RE: **Grants Reclamation Project – DP-200 Renewal – Response to September 12, 2000 NMED Letter Transmitting Comments / Questions on Renewal Application**

**HOMESTAKE MINING COMPANY
Grants Reclamation Project
DP-200 Renewal**

**RESPONSES TO
NEW MEXICO ENVIRONMENT DEPARTMENT
REGARDING QUESTIONS / COMMENTS ON DP-200
RENEWAL APPLICATION
PER
NMED LETTER DATED SEPTEMBER 12, 2000**

FIGURE 30. URANIUM CONCENTRATIONS FOR WELLS D1, X, S4, F, FB AND GH.

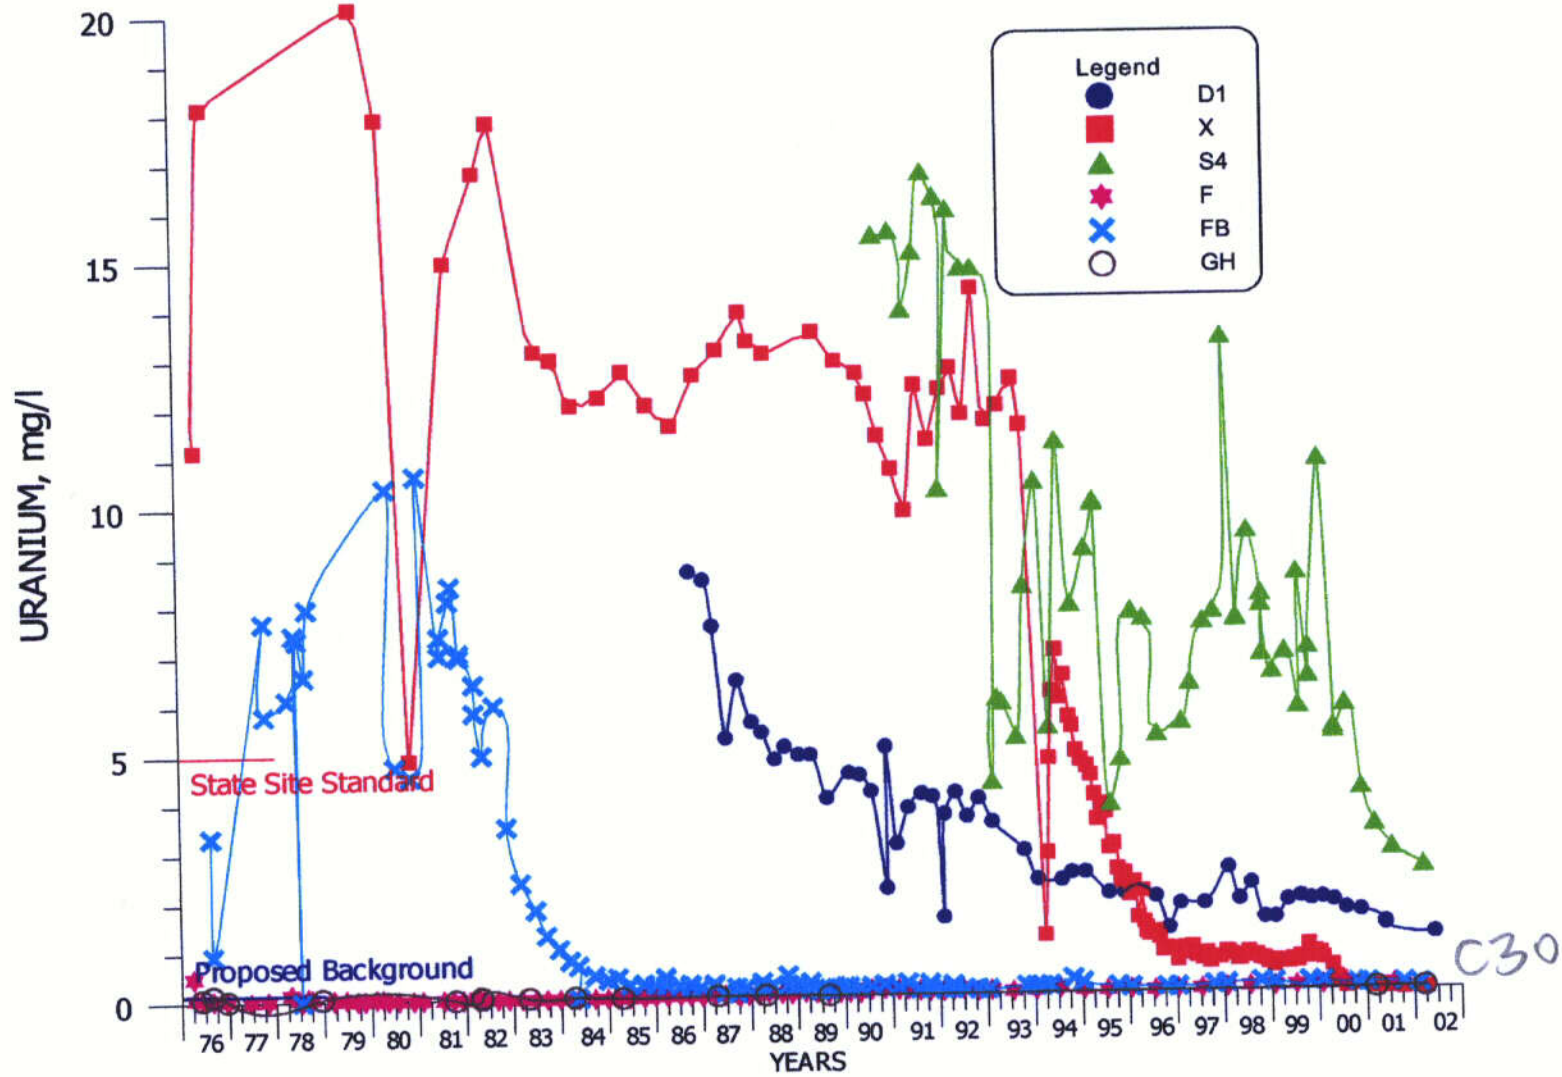
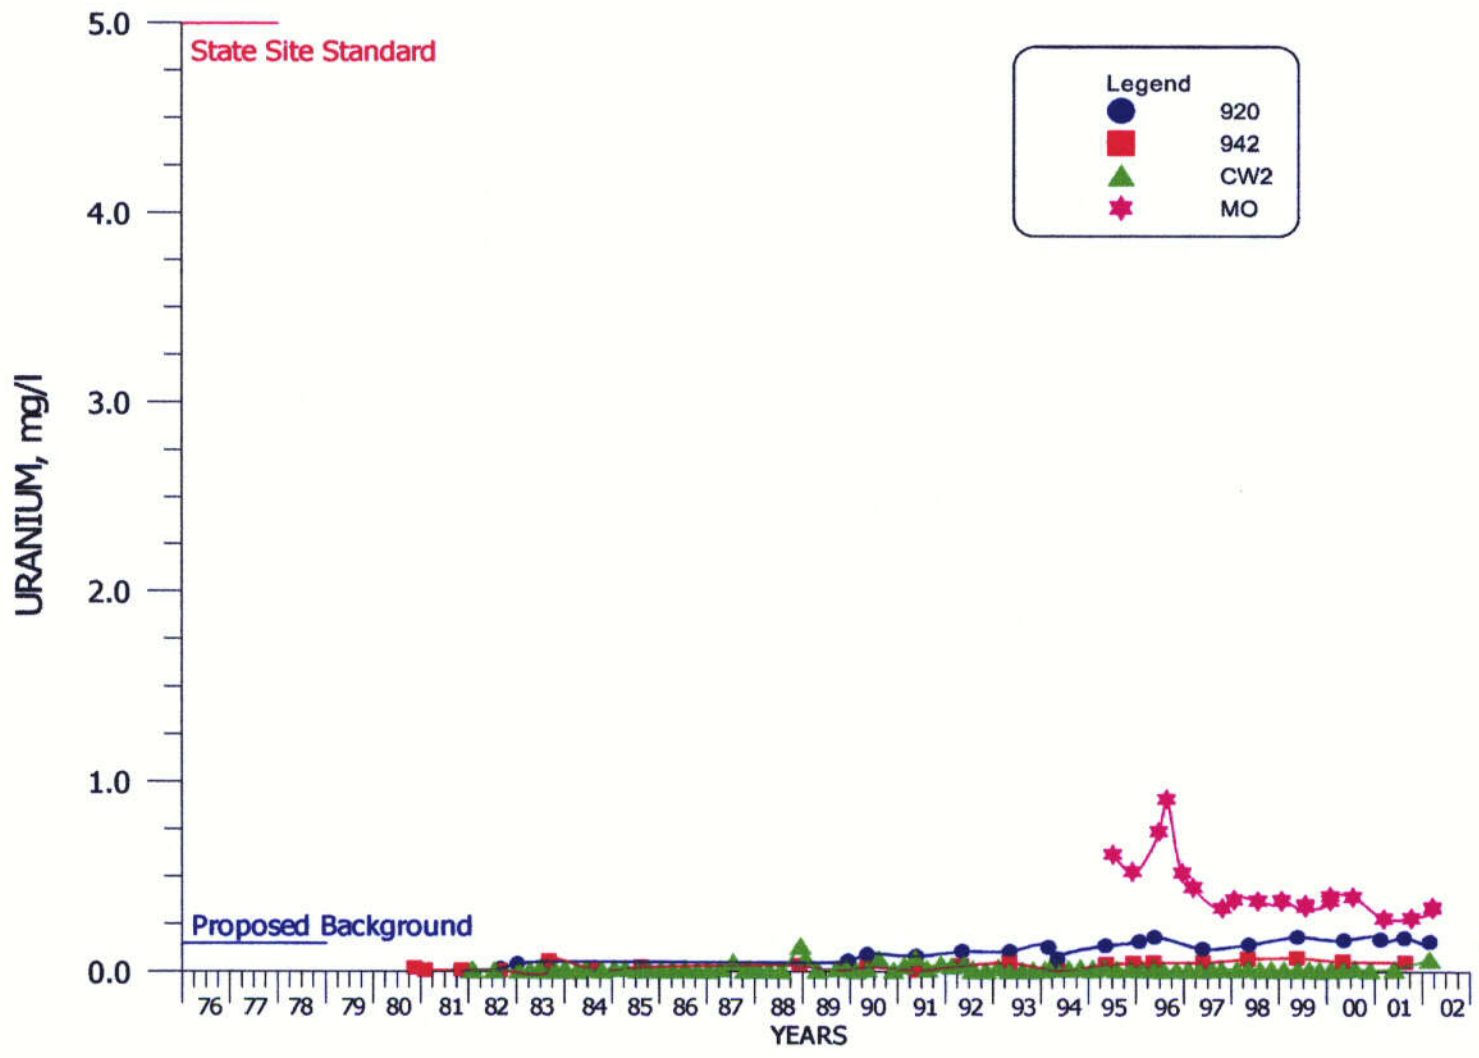
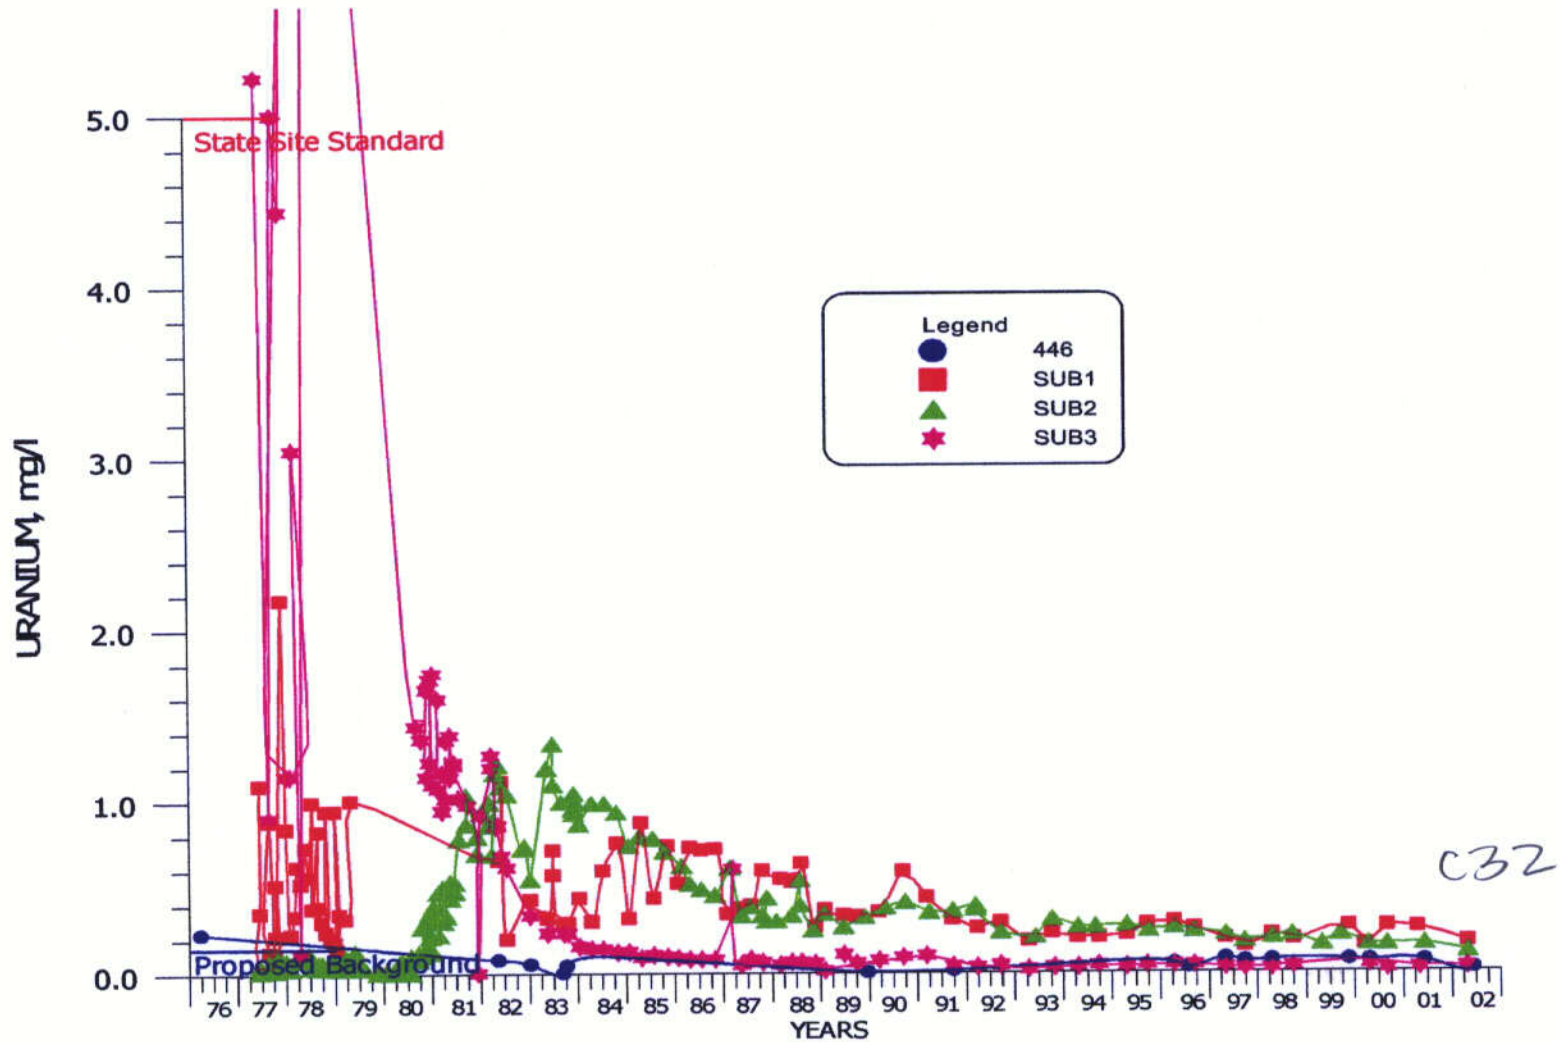
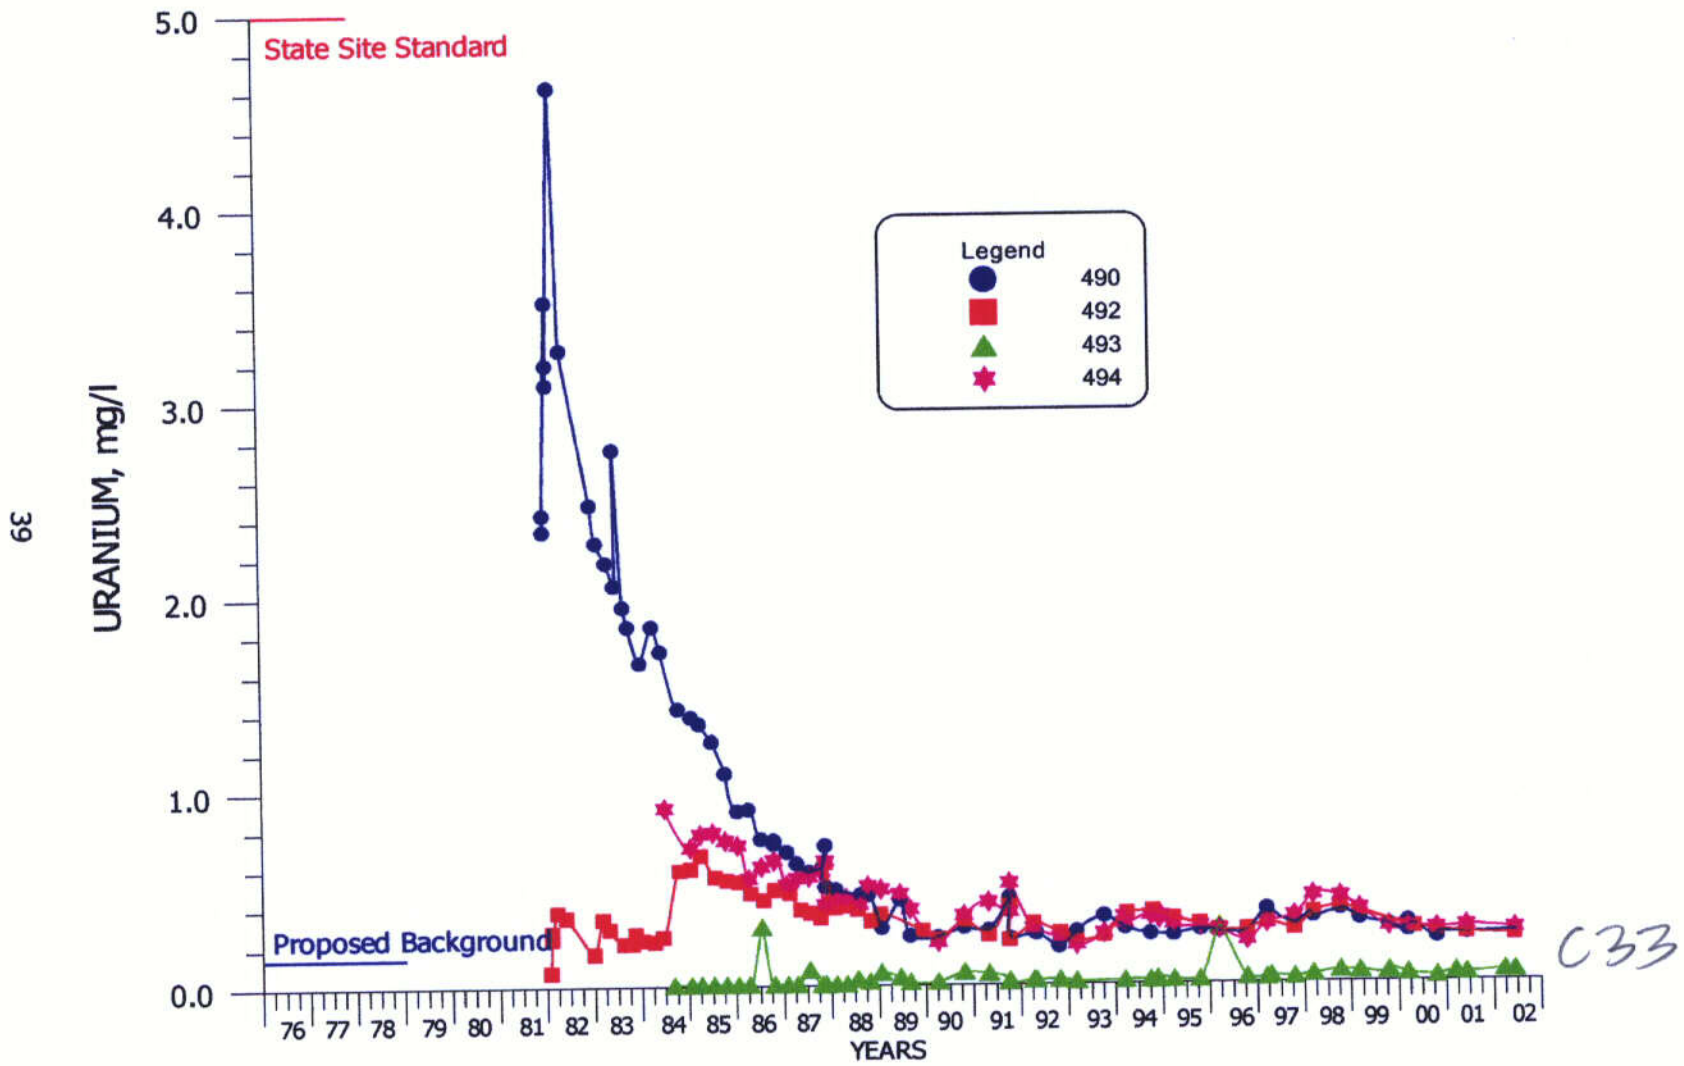
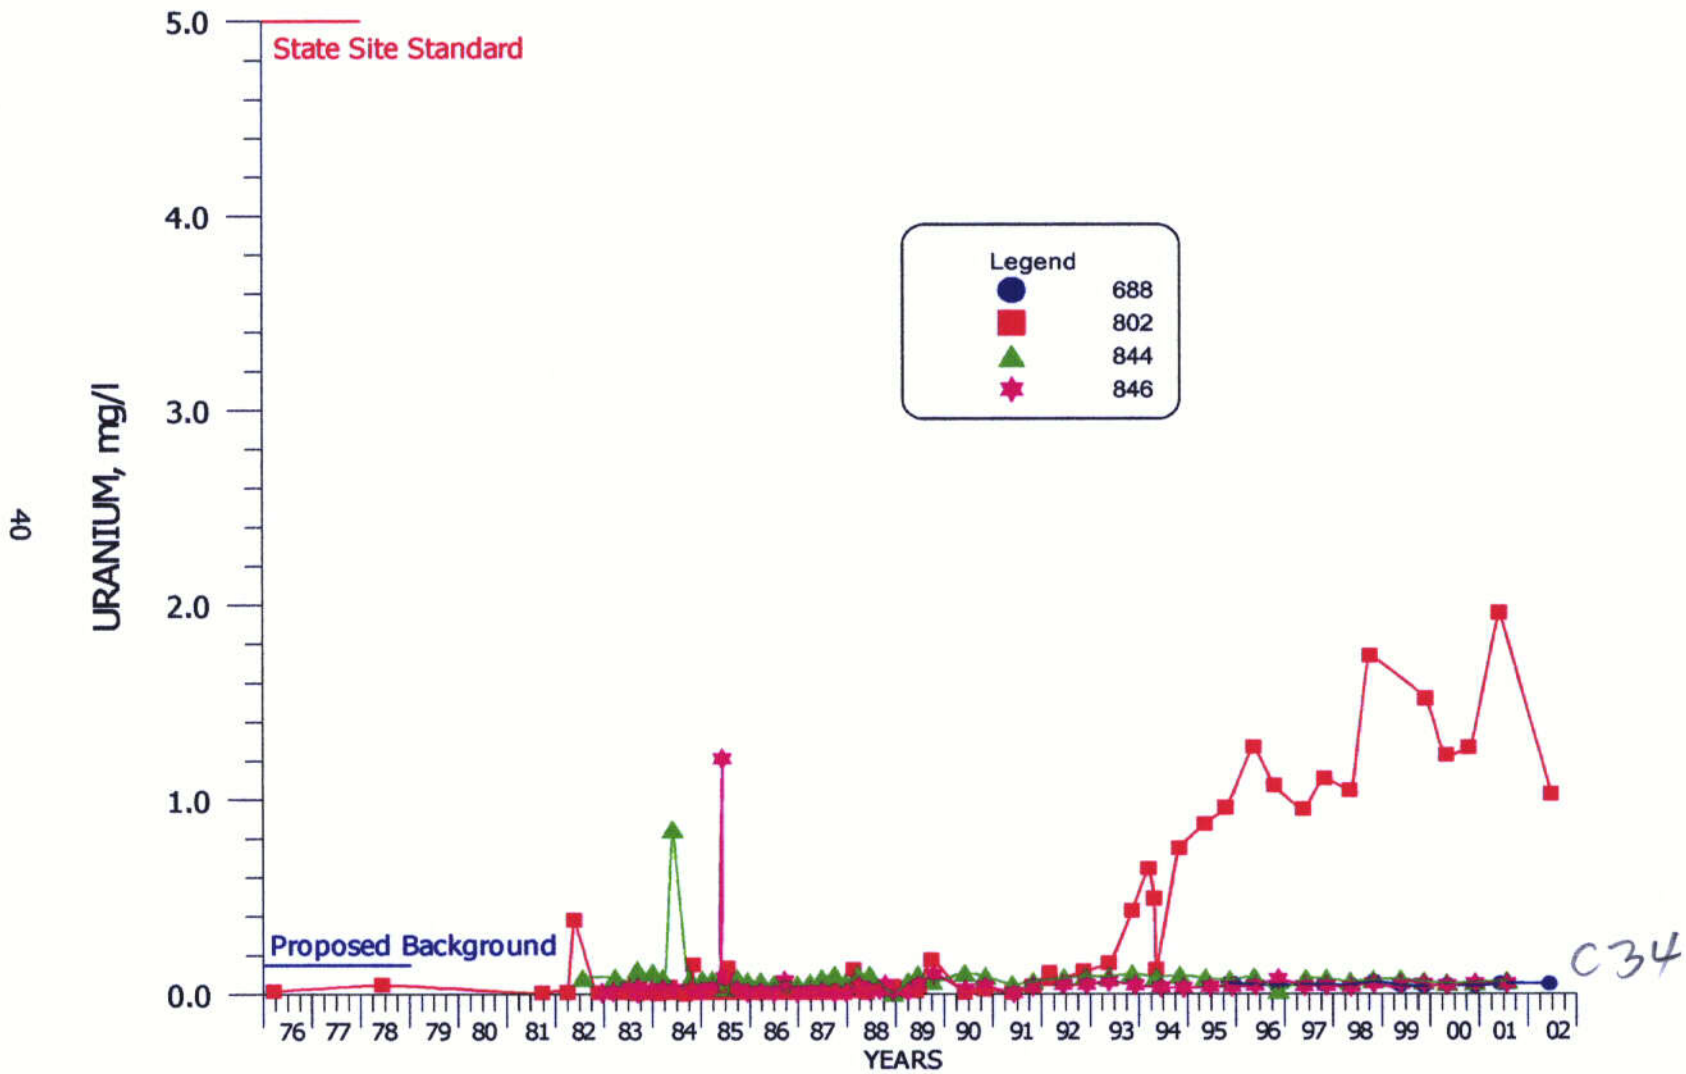
Comment: III.1.B. Graphs of Water-quality Data for the Table 2 Wells

Response: Plots for the routine monitoring wells from Table 2 of the NRC license are presented for sulfate, TDS, chloride, uranium, selenium, molybdenum and nitrate concentrations as Figures 15 through 49. The first group of wells for each of these constituents are presented for the three POC wells (Wells D1, X and S4) and

the initial figure also includes on site wells (Wells F, FB and GH). The following tabulation lists the figure numbers for each of the constituents:

CONSTITUENT	FIGURE NUMBER
SO4	15 – 19
TDS	20 – 24
Cl	25 – 29
U	30 – 34
Se	35 – 39
Mo	40 – 44
NO3	45 – 49

A few different vertical scales were required due to the large variations in parameter concentrations. The present State standard and the proposed background concentrations are presented on the plots.
